Request for Additional Information No. 406(4683, 4664, 4707), Revision 0

U. S. EPR Standard Design Certification

SRP Section: 09.02.02 - Reactor Auxiliary Cooling Water Systems

09.02.02-112

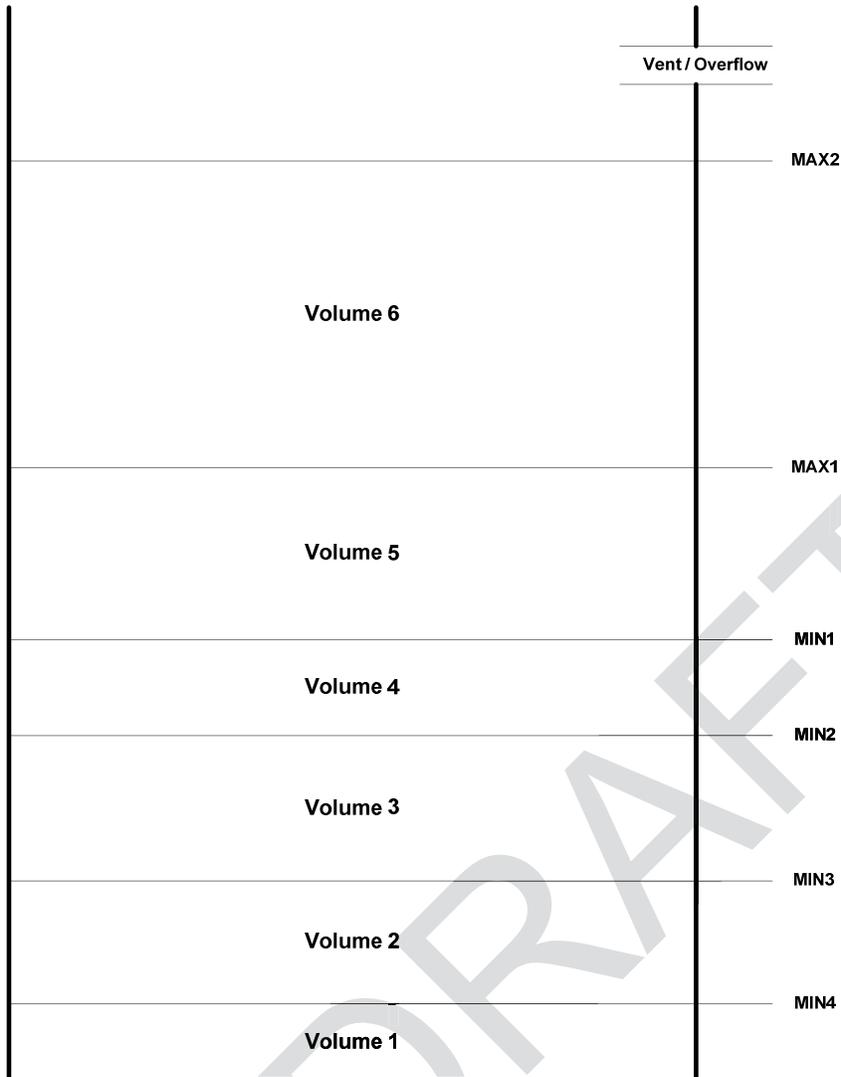
As previously identified in RAI 9.2.2-107 (4644/17637), the staff concluded that the use of a NSR/ Seismic Category II surge tank makeup water source is inconsistent with guidance provided in SRP 9.2.2 paragraph III.3C for a safety related seismic makeup source. Accordingly, the applicant needs to specify that the makeup water source is safety related, seismic category I. The applicant should also identify the flow rate and water volume that is available from the finally selected makeup source to confirm that the requirements of the CCWS system can be met. Based on a 20 GPM loss for valve seat leakage only for 7 days 201,600 gallons is required for make-up for one train.

Other considerations for this water make-up should include;

- a. Describe the surge tank level at the start of the scenario knowing that the non-safety make-up starts to make-up at MIN1 (if available) as described in Tier 2 FSAR Section 9.2.2.6.1 and that the non safety users isolate at MIN2 (based on delta flow) and switchover valves do not isolate until MIN3 is reached in the surge tank.
- b. For Item (C)2, describe the basis for total required makeup volume for 7 days and that continuous outleakage must be assumed for the 7 day period as discussed in SRP 9.2.2.
- c. The applicant should also discuss pump seal and valve packing leakage.

The CCWS surge tank volume and level design is as shown in the figure below.

To set the levels for operating volumes in each surge tank, the following considerations are applied:

- Normal Operating level is between MIN1 and MAX1
- Normal Demineralized Water makeup initiates at MIN1
- Non-Safety users outside of the Reactor Building automatically isolate at MIN2
- Common Header Switchover valves automatically isolate at MIN3
- CCWS Pump trip is at MIN4
- The minimum water level in any CCWS surge tank is calculated per ANSI/HI 9.8 (1998). This level is used to determine Volume 1 for each tank. Volume 1 will vary by tank due to slight variations in dimensions for each tank.
- Volume 2 between MIN3 and MIN4 is a water volume equal to 750 gallons per tank. This is the Post-Seismic 7 day leakage volume. This volume of water between MIN3 and MIN4 allows a CCWS train to run for 7 days on safety injection cooling with no surge tank make-up
- Volume 3 between MIN2 and MIN3 is equal to the system fluid lost during automatic isolation of a pipe rupture.

- Setting MIN1 level in each tank will provide Volume 4. Volume 4 will vary by tank due to varying sizes for each tank.
- Volume 5 is an open space volume allocated for thermal expansion of the CCWS system fluid.
- Volume 6 is an open space volume allocated for in-leakage from a HX tube rupture and offer time for operators to diagnose the malfunction and take action.

Per SRP 9.2.2, III, 3.C time zero for consideration of this post seismic leakage value begins at the low level alarm. For the CCWS design, the low level alarm in the tank is MIN3. MIN3 is the level at which “time zero” begins. At MIN3, seat leakage through the isolation valves for the non-safety related users is not a concern because those valves isolate at MIN2. Those valves are inside of the boundary created by closing the switchover valves at MIN3. Accounting for this post-seismic leakage allowance between MIN3 and MIN4 provides the CCWS with adequate capacity to operate for 7 days without reaching the MIN4 level which trips the CCWS pump.
